FAQ Number 07-0030

FAQ Title OMA Transition to Recovery Actions

Plant: Harris Nuclear Plant

Markup of NEI 04-02 Revision 2 (Reflects FAQ 06-0011 and 0012)

Figure B-4 General Process to Transition Operator Manual Actions

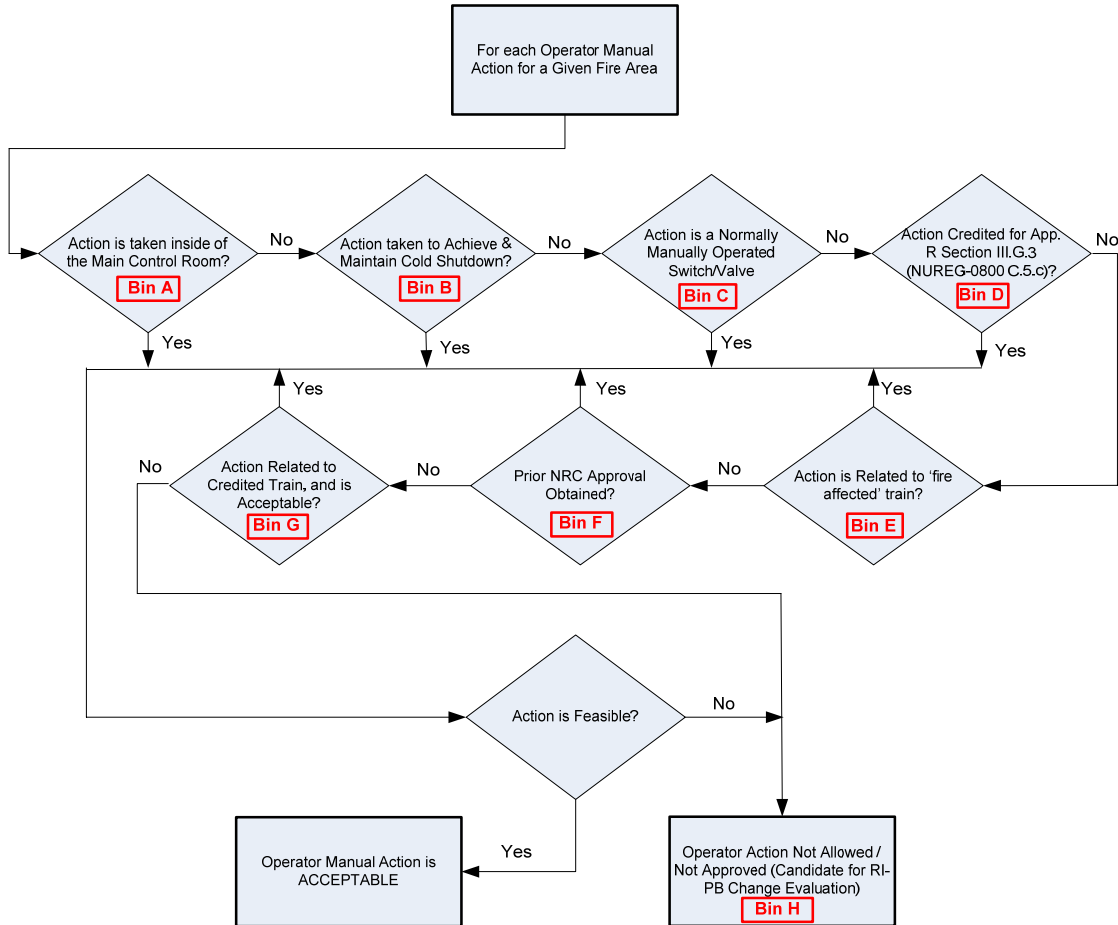
Figure B-4 depicts the general process for establishing OMA evaluation groups. This process “bins” transitioning OMA. The “bin” identifiers are for ease of reference.

OMAs that are allowed and/or have been previously reviewed and approved by the NRC (as documented in an approved exemption/deviation/safety evaluation report) can be transitioned without using the change evaluation process. Examples of allowed OMAs include:

Figure B-5 Allowed OMA in Fire Area Meeting 10 CFR 50, Appendix R, Section III.G.1 Separation Criteria

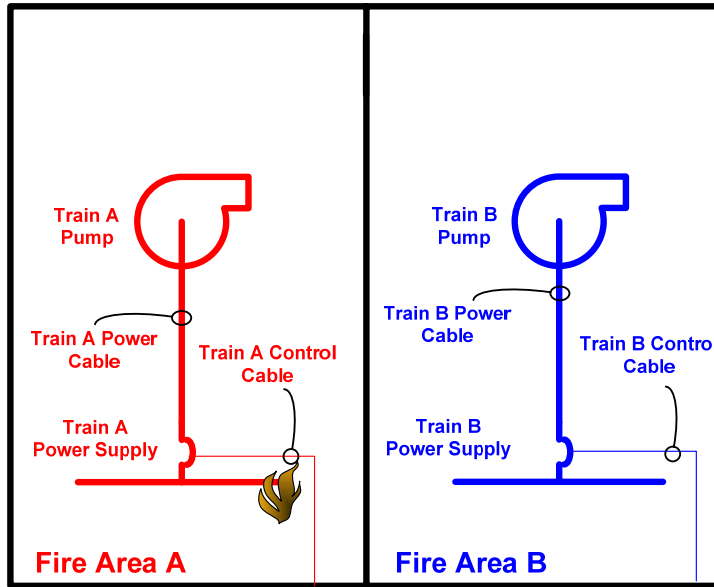
Bin E - Operation of fire affected equipment for fire areas that meet the separation requirements of Section III.G.1 of 10 CFR 50, Appendix R (or applicable sections of NUREG-0800). (See Figure B-5)

Fire Area A and B meet the separation criteria of 10 CFR 50 Appendix R Section III.G.1. A postulated fire in Fire Area A could result in the spurious starting of the Train A pump, which can be mitigated by an operator manual action to de-energize the Train A Power Supply to stop Pump A.

Figure B-6 Allowed OMA in Fire Area Meeting 10 CFR 50, Appendix R, Section III.G.2 Compliant – OMA for Fire Affected Train

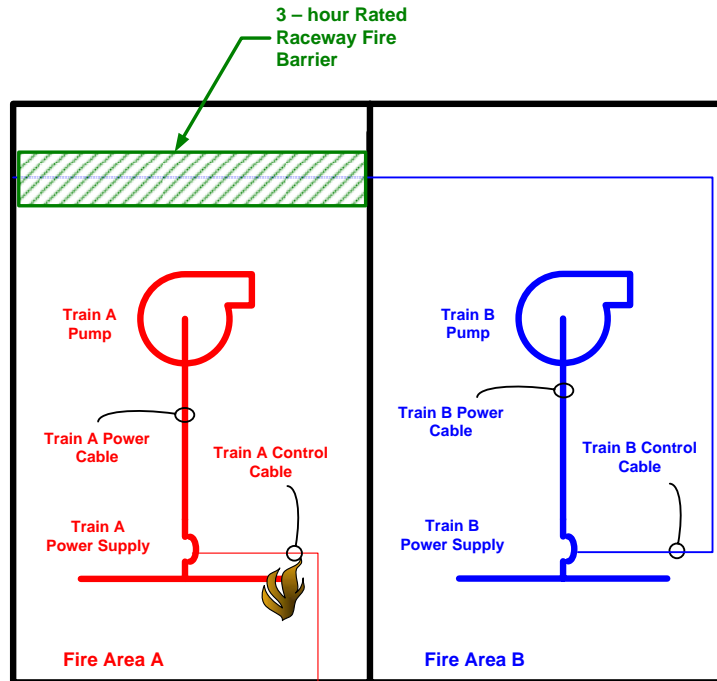
Operation of fire affected equipment for fire areas that meet the protection requirements of Section III.G.2 of 10 CFR 50, Appendix R (or applicable sections of NUREG-0800) for redundant trains. (See Figure B-6)

Fire Area B meets the separation criteria of 10 CFR 50 Appendix R Section III.G.2.a. A postulated fire in Fire Area A could result in the spurious starting of the non-credited Train A pump, which can be mitigated by an operator manual action to de-energize the Train A Power Supply to stop Pump A. This is functionally equivalent to Case in Figure B-5.

Figure B-7 Allowed Operator Manual Action – In Credited Success Path – Common Tank Suction

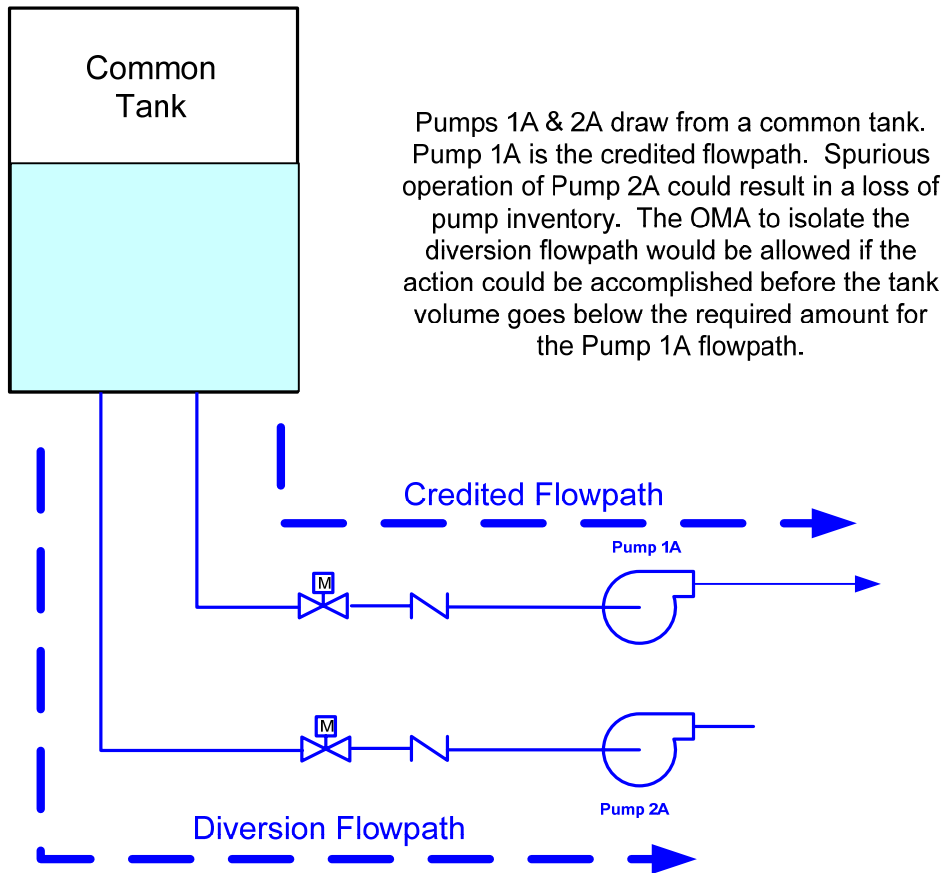
A special case of “fire affected train” exists where two redundant trains have components/cables in a given fire area, and both trains take suction from a common tank. In this case, a manual action would be allowed (and no change evaluation would be required) to secure the fire affected train, since the credited train is protected (meets III.G.2 requirements) even though the manual action would need to be accomplished before the common tank level decreased to the point where operation of the credited train would be affected. This is acceptable since the common point in the system is the tank, which is still free of fire damage. This example was discussed in the June 9, 2006 public meeting. (ML061980016)

Figure B-8 OMA – In Credited Success Path – Auxiliary Feedwater Flow Diversion [not allowed per NRC Ref. ML072820168]

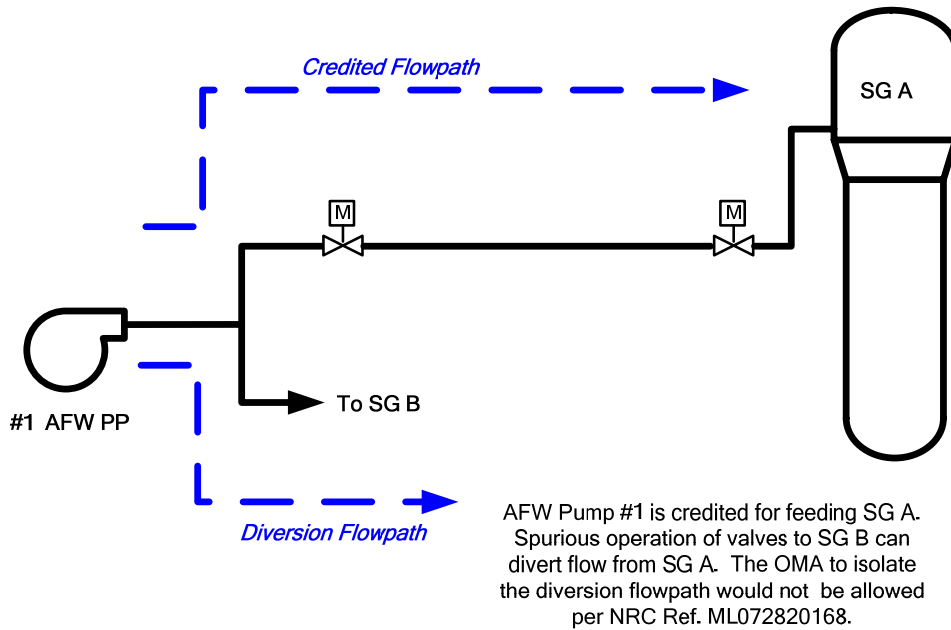
An example where an OMA to address spurious operations that affect the credited safe shutdown success path would not be allowed is the case where the credited function is to inject water to one of the Steam Generators (reactor) and a spurious operation causes a diversion from the credited flow path. Even though the minimum required injection flow can be maintained and the OMA can be accomplished prior to the function being disabled, the operator manual action is not allowed and a change evaluation would be required since the credited train is not free of fire damage (the diversion of flow must be terminated at some point or the credited safe shutdown path will not be successful). An example of this configuration is BWR example 3 of the June 9, 2006 public meeting (ML061980016). This clarification of the ‘credited train not being free of fire damage’ was provided by the NRC on September 20, 2007. (ML072820168)

Figure B-9 Determination of Post-Transition Recovery Actions and Necessary Supporting Analyses

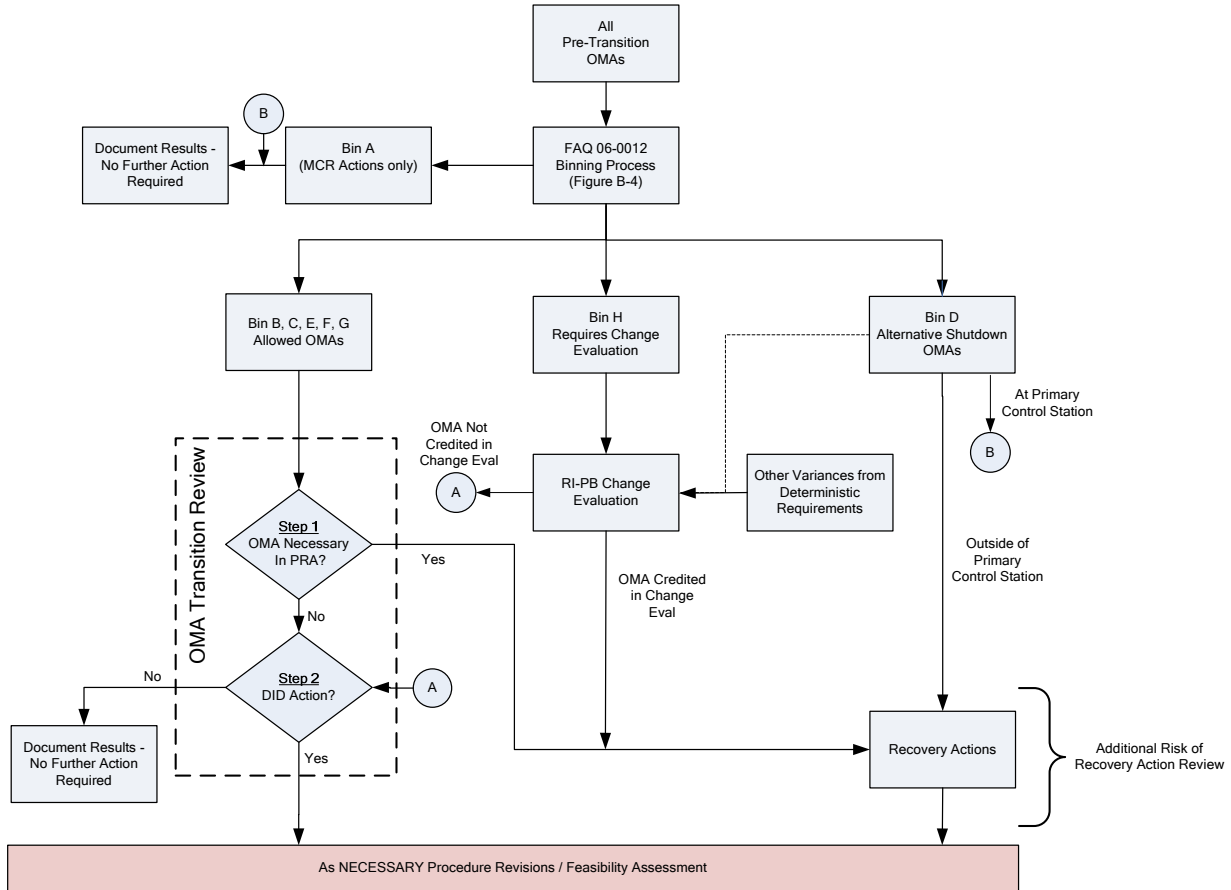
In addition to the determination of the OMAs that require a change evaluation (i.e., determination of OMA evaluation groups in Section B.2.2.4.1), the process outlined in Figure B-9 should be used to determine the scope of recovery actions and defense-in-depth actions that will remain following NFPA 805 transition.

The process should begin with the binning of all pre-transition OMAs per FAQ 06-0012, as described in Section B.2.4.1. The outcome of the binning process, with respect to the determination of credit taken for recovery actions, results in the following:
